From: Freitas, Gabriela
Sent: Thursday, September 7, 2023 9:48 AM
Cc: Tackett, Deborah; Seiberling, James; Kallergis, Nick; Gonzalez, Jessica; Herrera, Miriam
Subject: FW: Ritz Sagamore

**Re: HPB 23-0574 -- Ritz/Sagamore Certificate of
Appropriateness Application for Properties
at 1 Lincoln Road and 1671 Collins Avenue.**

Heritage Architectural Associates (HAA) has been commissioned by New National LLC to provide an analysis of the Ritz-Sagamore Project as it relates to the governing ordinances and guidelines, including the City of Miami Beach's Land Development Regulations (LDR) and the Secretary of the Interior's Standards and Guidelines for the Treatment of Historic Properties. This report only addresses items that relate to the COA Criteria of the LDR, which include the Secretary of the Interior's Standards. Other items, such as those regarding setbacks, excavation, sea level rise, and zoning, are beyond the scope of this document.

*Figure 9. Proposed Site Plan for Ritz-Sagamore Project.
(Kobi Karp Architecture and Interior Design, Inc., Drawing A1.50, 5/8/2023)*

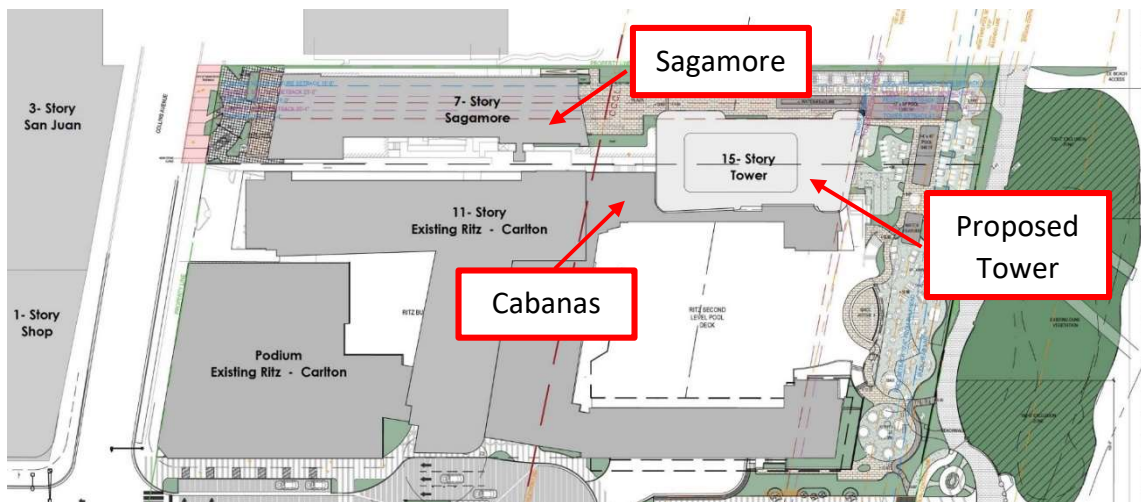
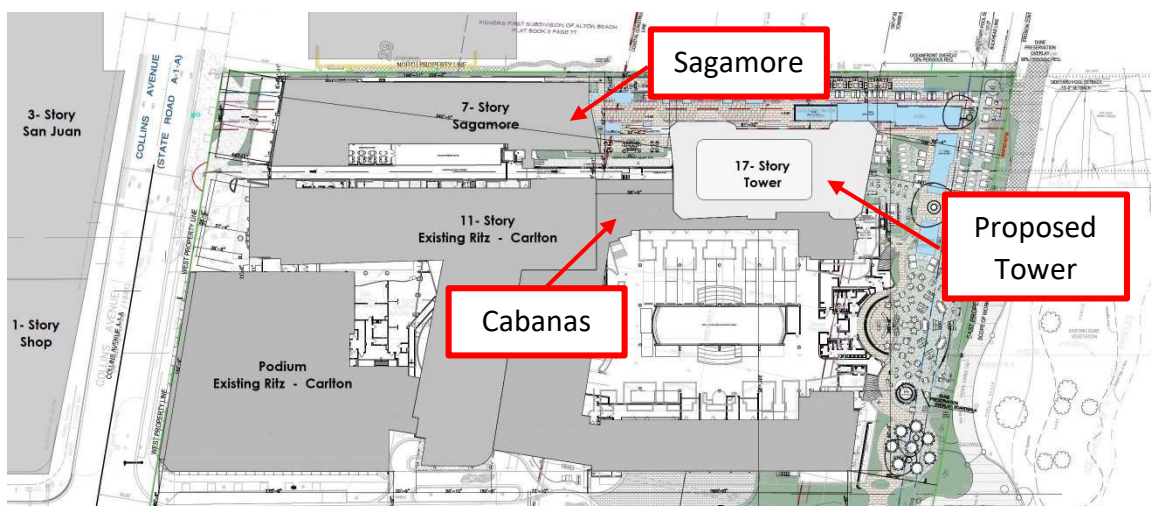
The Ritz-Sagamore Project proposes the construction of a 15-story, 182'-10" (202'-10" overall) tower behind the 7-story Sagamore Hotel. In 2019, the maximum building height for additions on lots of 115,000 square feet or greater was increased to 200 feet for RM-3 zoned oceanfront properties between 16th and 21st Streets. The subject properties, with combined lot sizes, meet the lot size criteria. The tower would be cantilevered over the cabanas located to the east of the Ritz-Carlton Hotel. (Figure 9)

The previous iteration of the project, from 2021, featured a 17-story, 200' tower (224'-0" overall) behind the Sagamore Hotel. The tower was to be cantilevered over the Ritz Carlton cabanas. (Figure 10)

*Figure 12. Proposed 2021 west elevation.
(Kobi Karp Architecture and Interior Design, Inc., Drawing A4.06, 11/12/2021)*

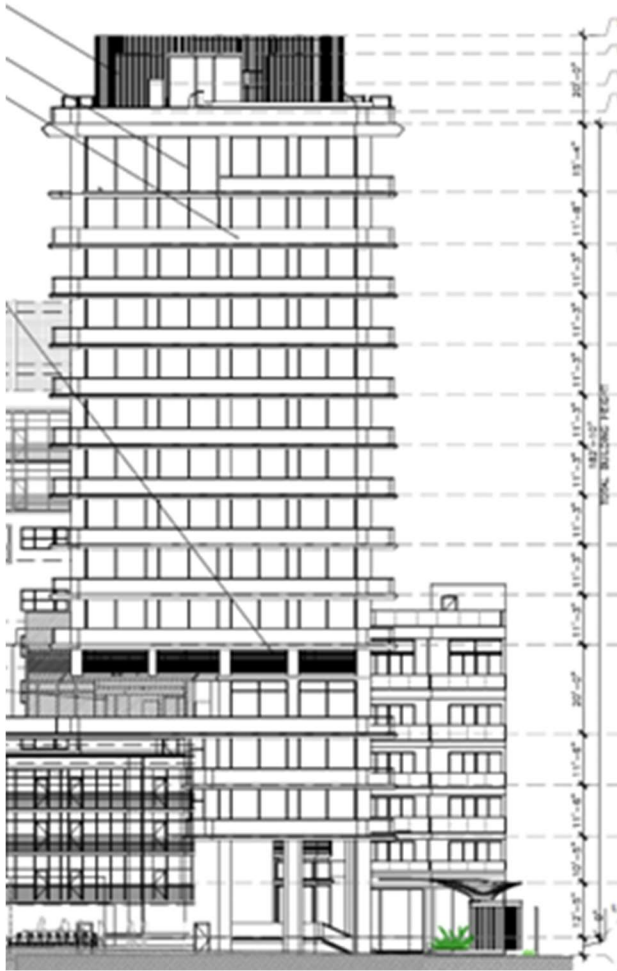
The proposed 182'-10" tower located behind the Sagamore Hotel would be out of scale with its surroundings and would dwarf the historic hotel (Figure 11), the same as the previous project. (Figure 12)

*Figure 14. East elevation of 2021 proposed tower.
(Kobi Karp Architecture and Interior Design, Inc.,
Drawing A4.04, 11/12/2021)*

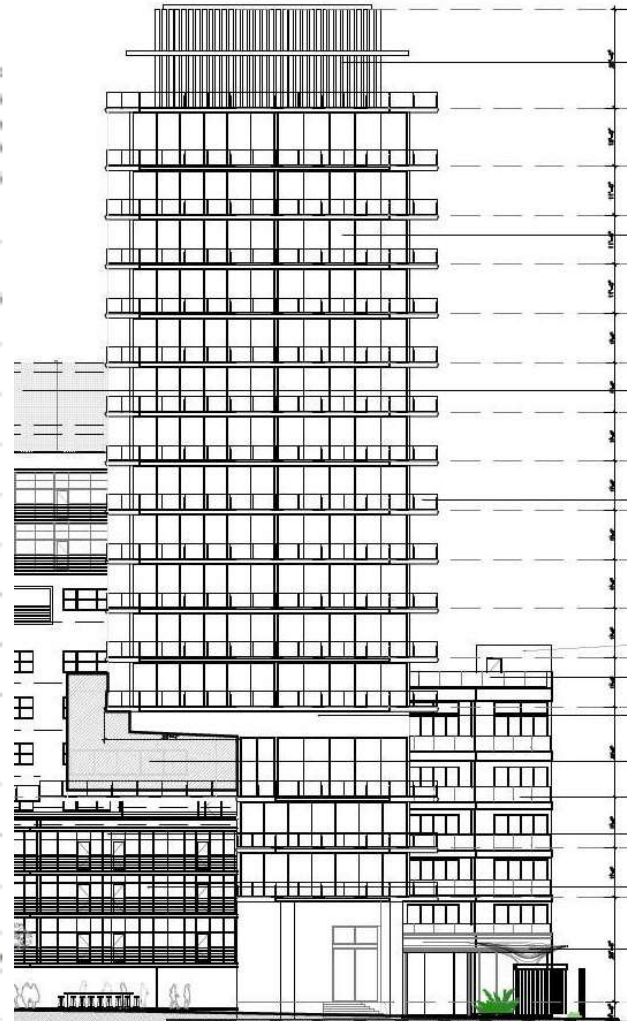
The overall height of the current proposed tower is 202'-10". The overall height of the tower in the 2021 proposal was 224'-0", a difference of 21'-2". (Figure 13, Figure 14)

The height to the top of the habitable space in the current proposed tower is 182'-10". The height to the top of the habitable space in the 2021 proposal was 200'-0", a difference of 17'-2".

Figure 44. Existing shadowing at Equinox, 10 a.m.
(Heritage Architectural Associates with K4 Architecture)

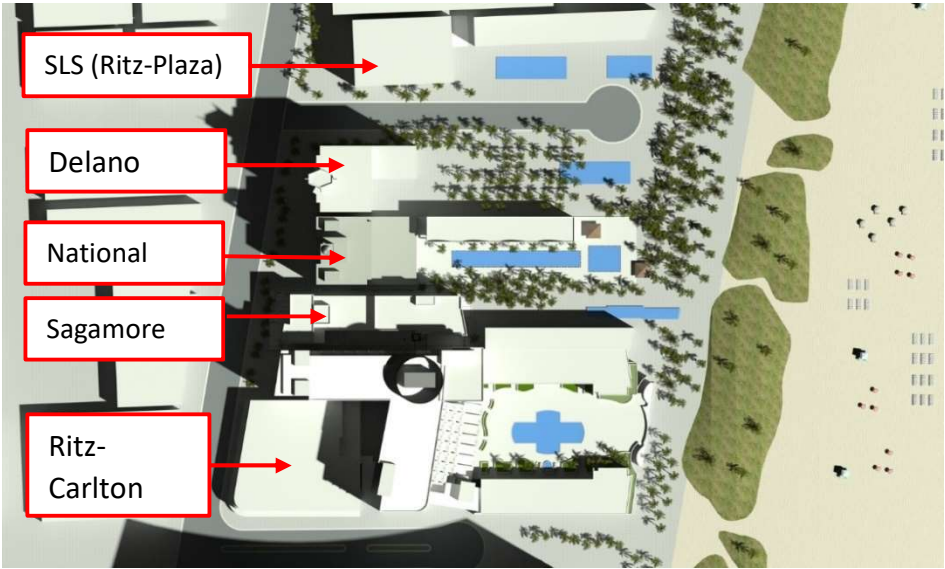
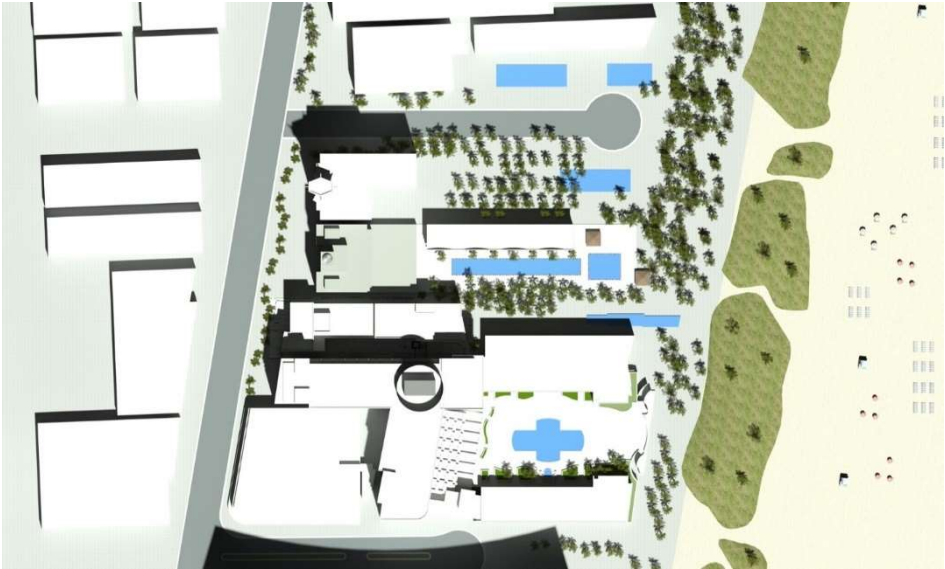
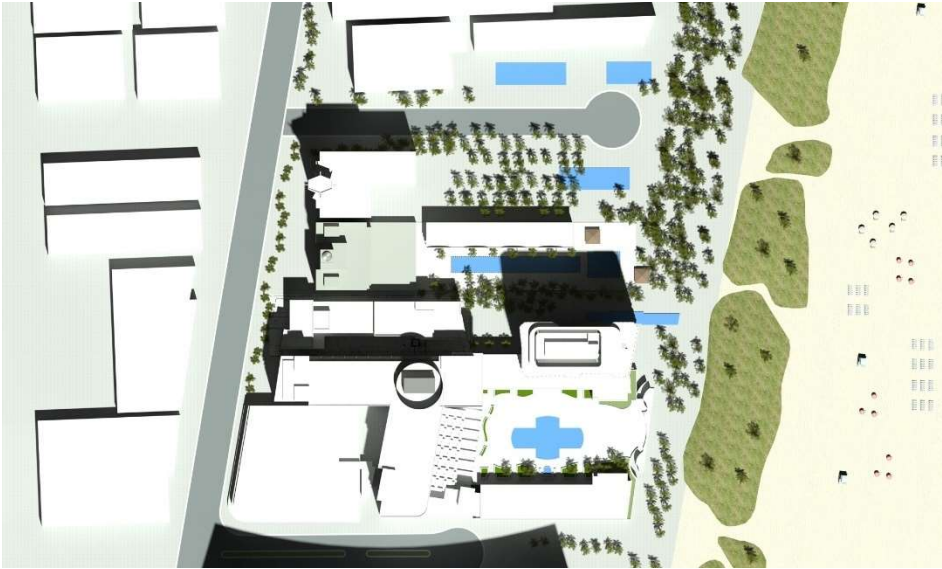
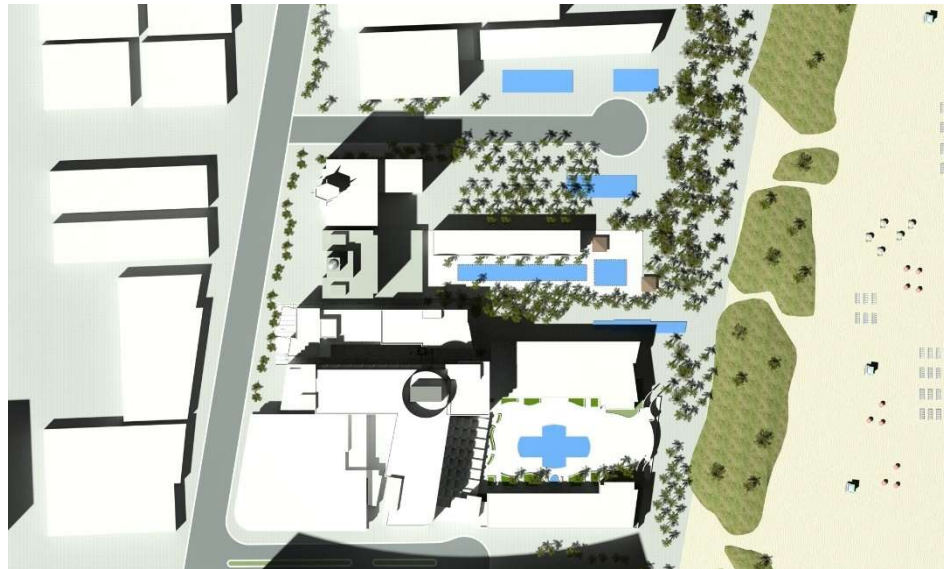
According to the solar shading studies shown, the addition of a 202’-10” building on the adjacent lot behind the Sagamore will have a significant impact on the National Hotel and will cast shadows on the pool area from approximately 10 a.m. until 3 p.m. during the Equinoxes, which was also the case with the 2021 proposed project. (Figure 44-Figure 55)

Figure 56. Existing shadowing at Winter Solstice, 10 a.m.
(Heritage Architectural Associates with K4 Architecture)

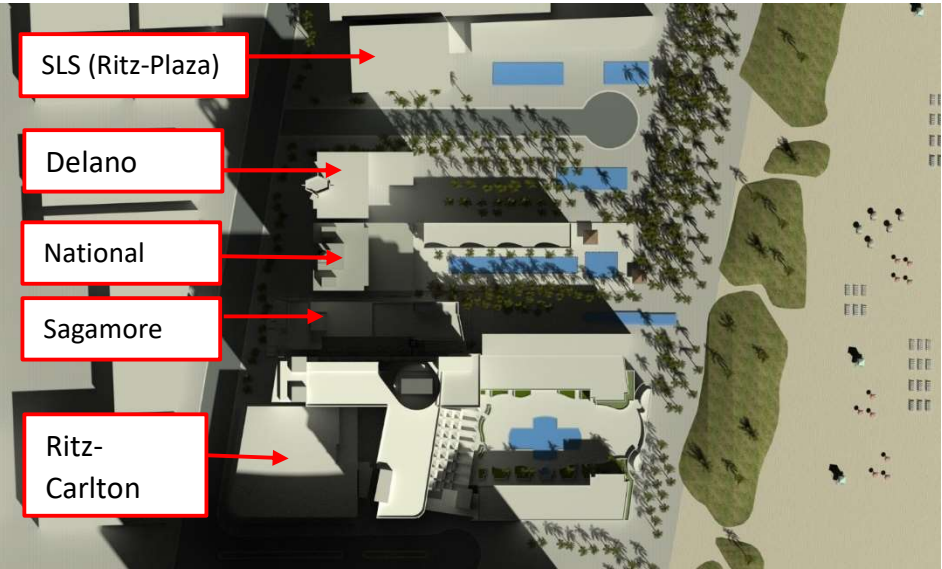
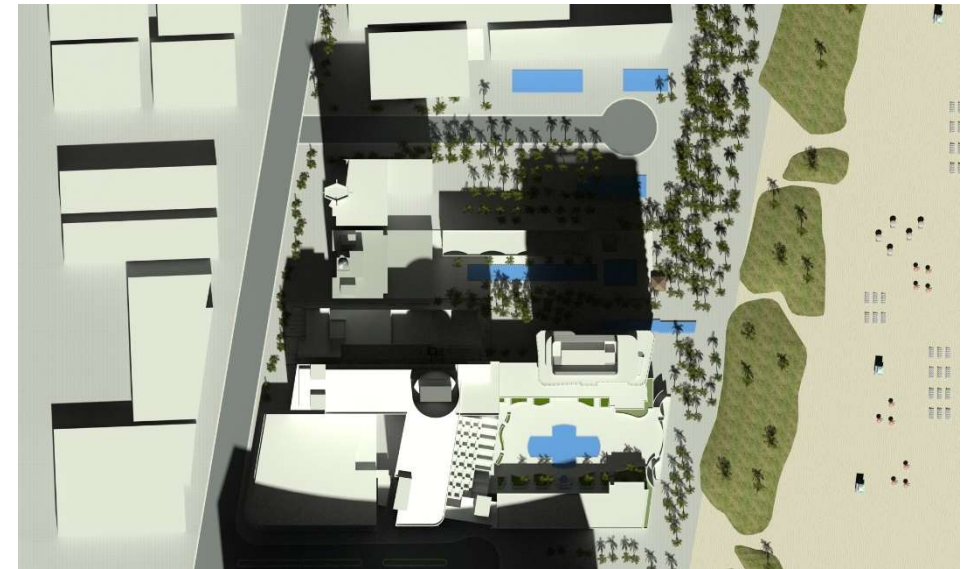
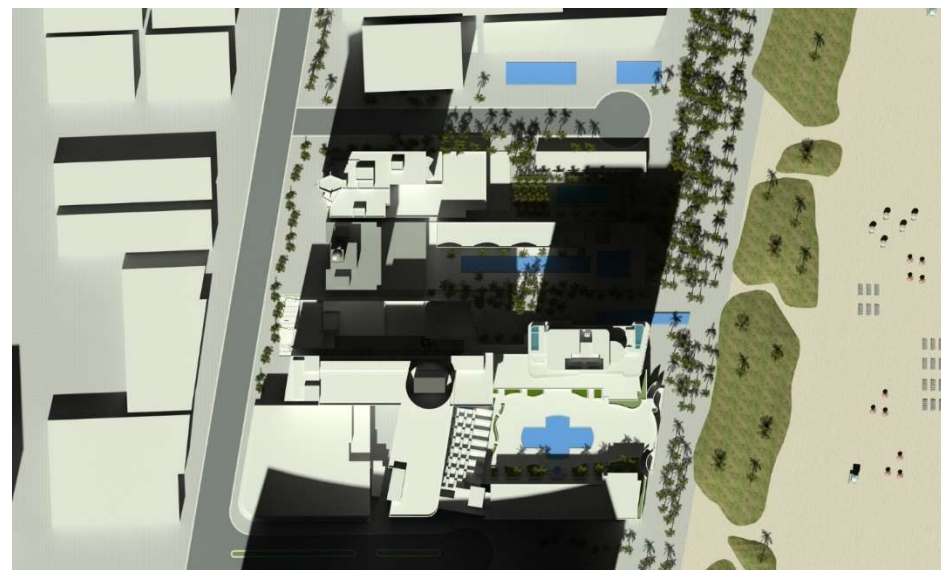
Significantly, the pool area at the National will be enveloped in shadows cast by a 202’-10” building during most of the day at the Winter Solstice, a time of year when occupants will be expecting sun in these light-inspired areas. The studies also show that the pool area at the Delano Hotel, two doors away from the Sagamore, will be in shadows cast by the 202’-10” tower from 11 a.m. after 2 p.m. during the Winter Solstice. (Figure 56-Figure 73) This was also the case with the 2021 proposed project.
